Regulatory Updates on Building Plan Requirements

BUILDING PLAN & POLICIES DEPARTMENT
BUILDING PLAN & MANAGEMENT GROUP

Skylight within setback

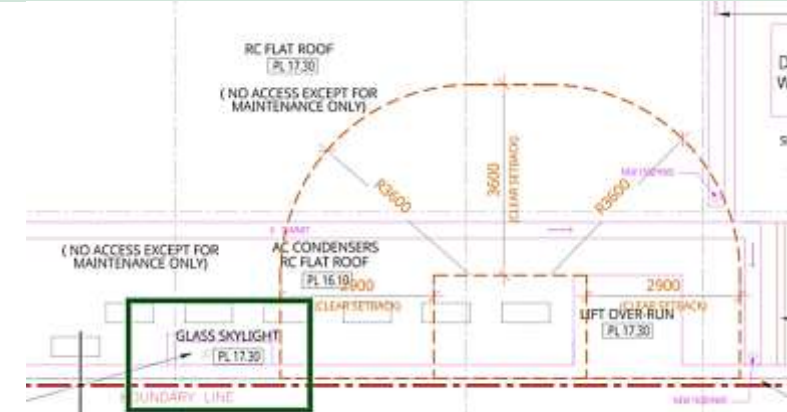
- Not acceptable

QP declared landed house as Type 1 building

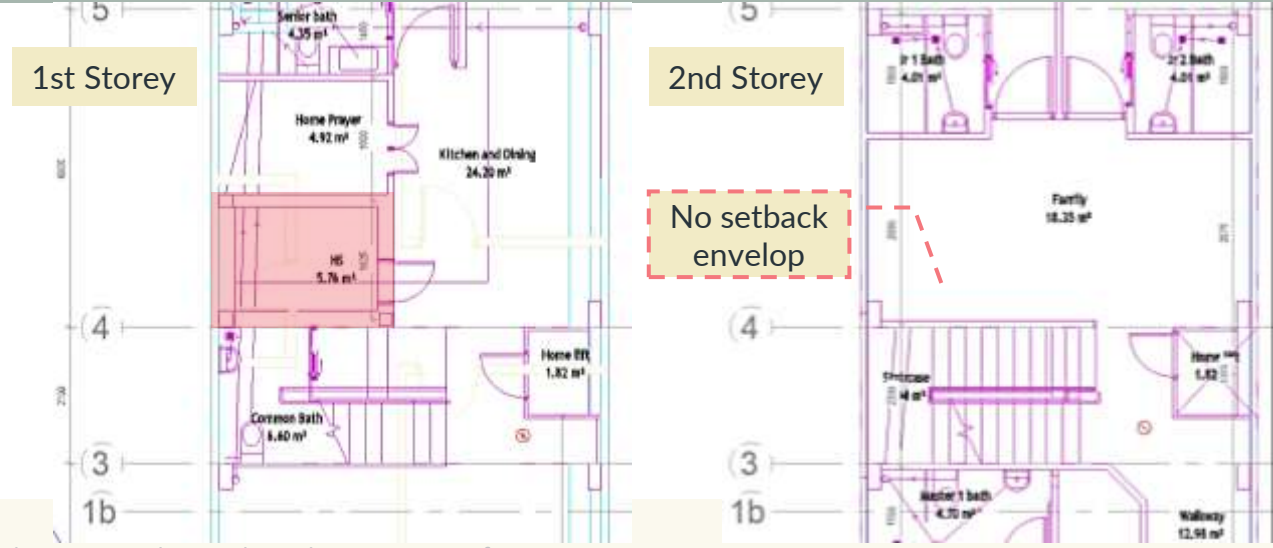
➤ \$450 plan fee paid, instead of \$900
